RS-14-007

Braidwood Station, Units 1 and 2  
Facility Operating License Nos. NPF-72 and NPF-77  
NRC Docket Nos. STN 50-456 and STN 50-457

Subject: Second Six-Month Status Report in Response to March 12, 2012 Commission Order Modifying Licenses with Regard to Requirements for Mitigation Strategies for Beyond-Design-Basis External Events (Order Number EA-12-049)

**Second Six-Month Status Report for the Implementation of Order EA-12-049, Order  
Modifying Licenses with Regard to Requirements for Mitigation Strategies for Beyond-  
Design-Basis External Events**

Updated Mechanical One Line Diagrams

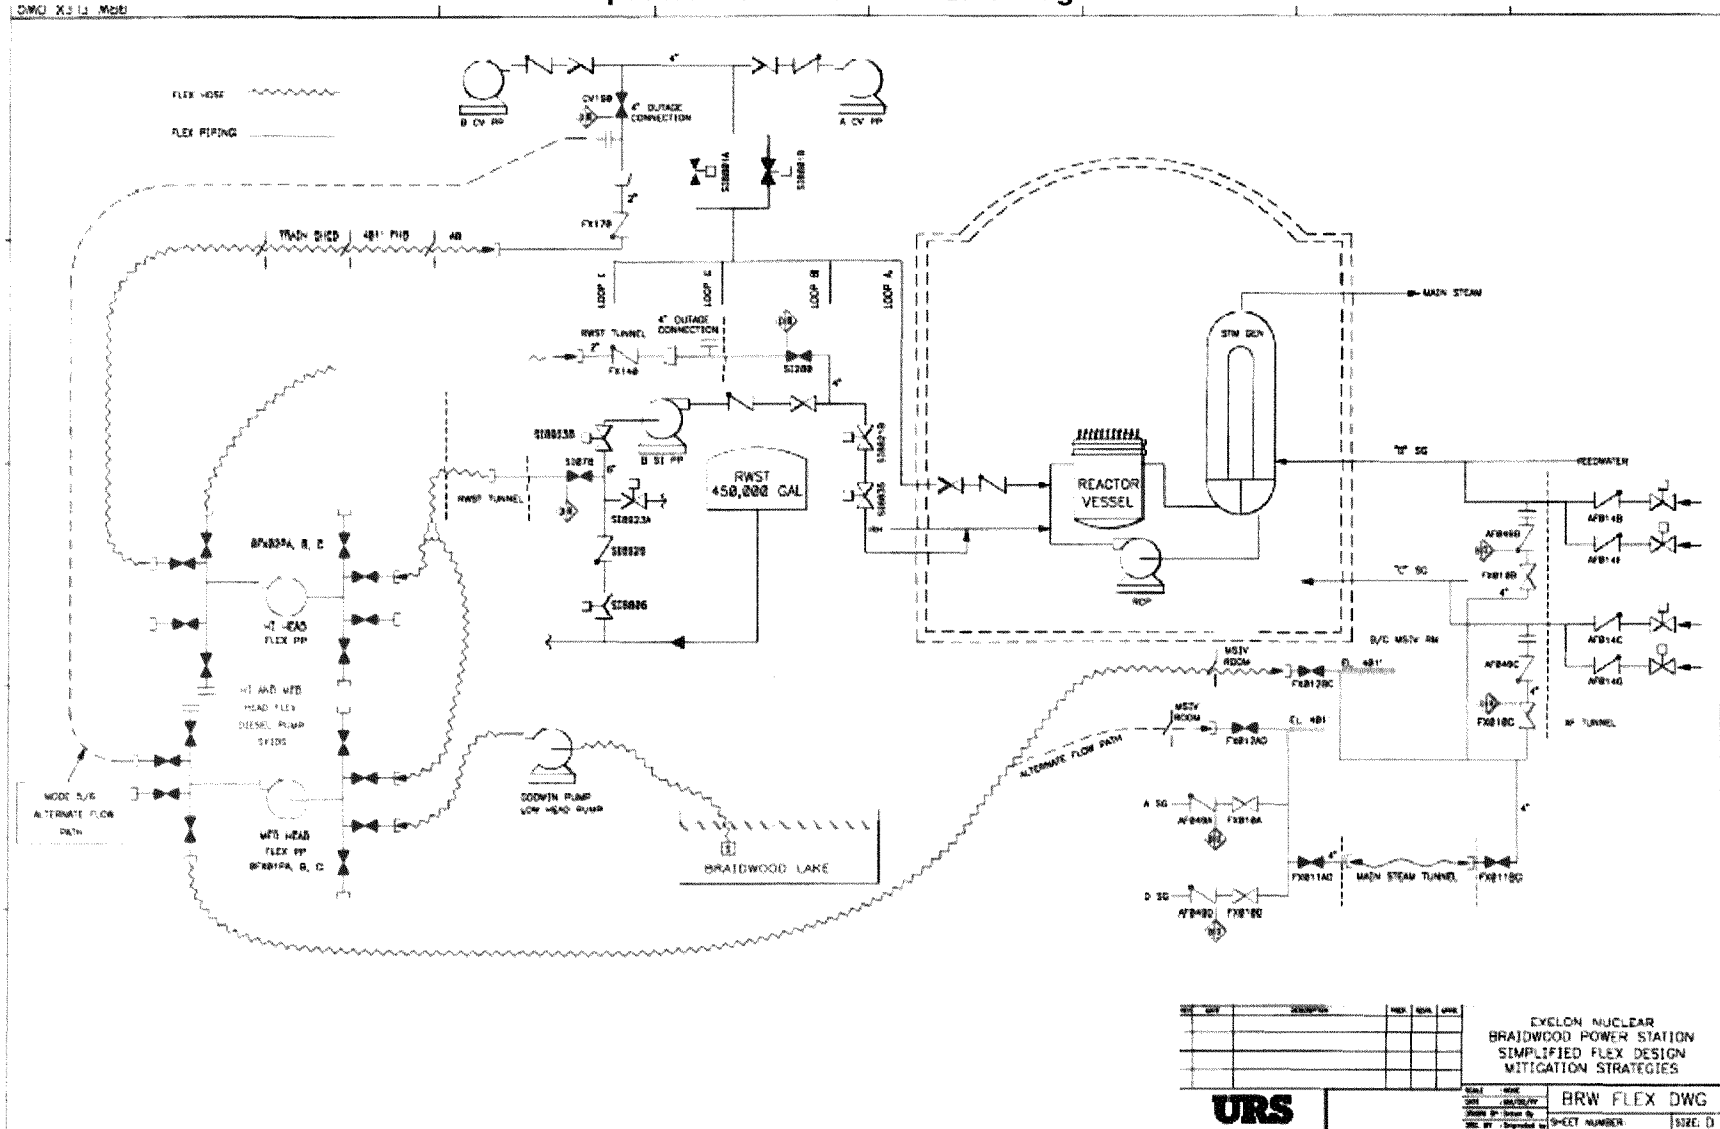
Section: Attachment 3 Conceptual Sketches.

Reason for Change: Modification design details were refined as part of the standardized modification design process resulting in changes to the mechanical conceptual sketches.

Change: Current mechanical conceptual sketches are attached to this document. See Attachment 3.
